Development Review Committee
City Parking Structure One Stop
February 18, 2016

- Applicant:** City of Santa Clarita
- Location:** The City Block is surrounded by Main Street, Lyons Avenue, Railroad Avenue, and 9th Street; Assessor Parcel Nos. 2831-007-900; 901; 902; 903; 904; 905; 906; 907; and 908.

- Proposal:** The project consists of a 55' tall, five-level parking structure, with approximately 400 spaces. The structure would provide subterranean access to the parking area for the mixed-use residential component of the City Block development. For information purposes, other components of the City Block include a two-story, 17,688 square-foot Laemmle Theatre with seven screens and 475-525 seats with 2,300 square feet of retail, and a Mixed Use element consisting of 46 units and 20,240 square feet of retail space. One building would be four stories tall, the other would be five stories tall. Those elements would be processed under separate entitlements.

2/19/15 (DRMS) Development Review | Underground Parking.dwg

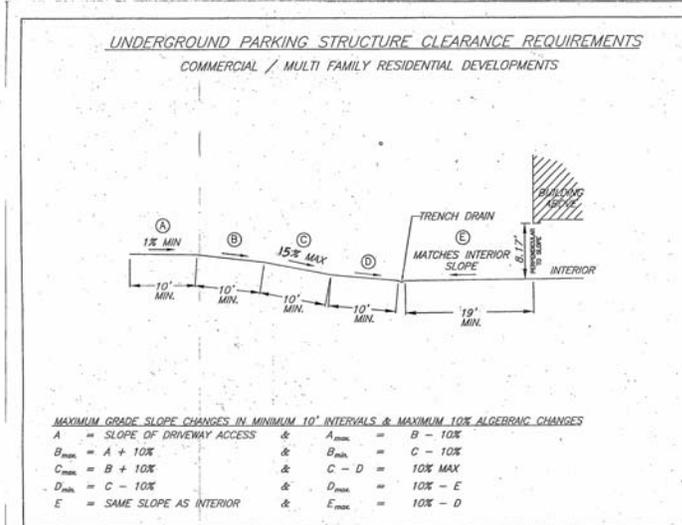
1. An 8'-2" clearance is required at the lowest point (usually the opening to the parking garage). This clearance is required for 19' beyond the opening (at the same slope as the interior of the parking structure) before the driveway may begin its ascent. The remainder of the ascent shall have maximum 10% algebraic grade difference with grade breaks at minimum 10' intervals or the equivalent vertical curve. Water shall be intercepted by a trench drain at the base of the driveway, and the plan shall show how this water will drain from the site. See attached sketch.
